SERVICE BULLETIN

APPLICABILITY: 2019-24MY Forester
2022-25MY Forester Wilderness

NUMBER: 12-279-26

SUBJECT: Power Rear Gate Unit / Design Change

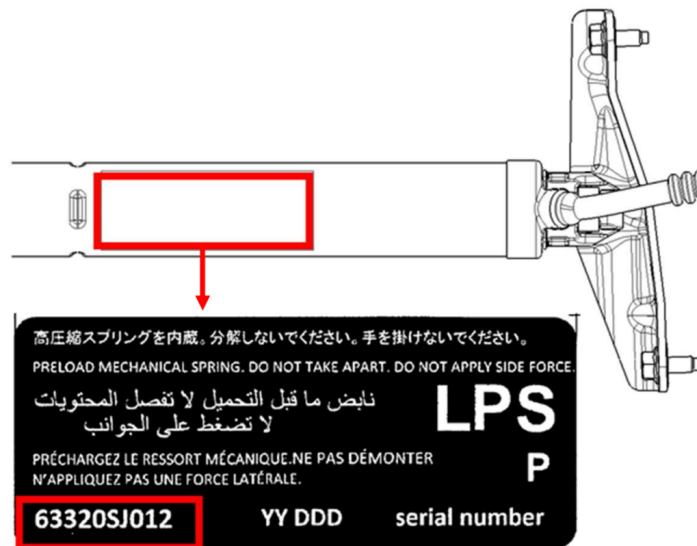
This bulletin announces a design change to the Power Rear Gate Drive (PRG) Unit. The new design was implemented to address rare concerns about a very slight drop immediately after the gate is fully open. The updated design incorporates an enhanced internal spring force to prevent gate movement at full open height. If this concern is reported, follow the procedure outlined in this bulletin.

To determine if the part is post improvement, inspect the label. The part number is located in the lower left-hand corner.

Part Description	New Part Number
UNIT ASSEMBLY-POWER REAR GATE LEFT	63329SJ013
